RCA-78-25-004-2: Replace 12V Battery and Brackets

Note: This document supersedes RCA-78-25-004-1. Revision 2 updates the approximate build dates.

Document Type	Customer Satisfaction Campaign Bulletin
Date	August 1, 2025
Affected Region(s)	USA, Canada
Affected Model(s)	R1T, R1S
Model Year(s)	2025
Approximate Build Dates	August 2024-January 2025
 Refer to Open Containments in ServiceOS to determine if this document applies to a specific vehicle.	
Vehicle System	78 - Low Voltage Electrical
Minimum Service Location	Mobile

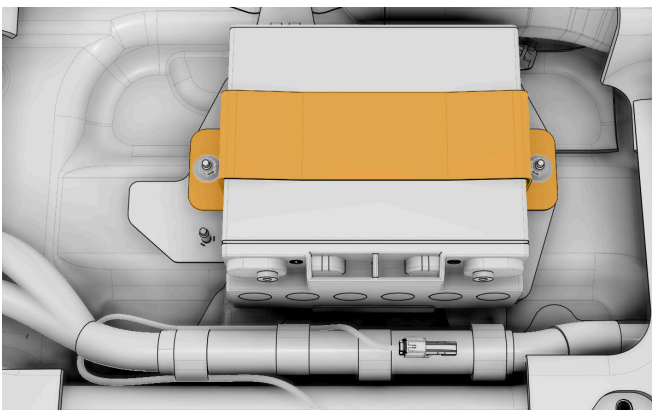
1. Remove and discard: Battery, 12V, Primary (refer to service manual procedure 786410010).
2. Remove and discard: Bracket, 12V Battery, Lower (refer to service manual procedure 786620010).
3. Clean the highlighted area(s). Use alcohol wipes or rubbing alcohol on a clean cloth.

4. Install, using new component(s): Bracket, 12V Battery, Lower (refer to service manual procedure 786620010).
5. Install, using new component(s): Battery, 12V, Primary (refer to service manual procedure 786410010).

Note: During installation: Replace the highlighted component(s).
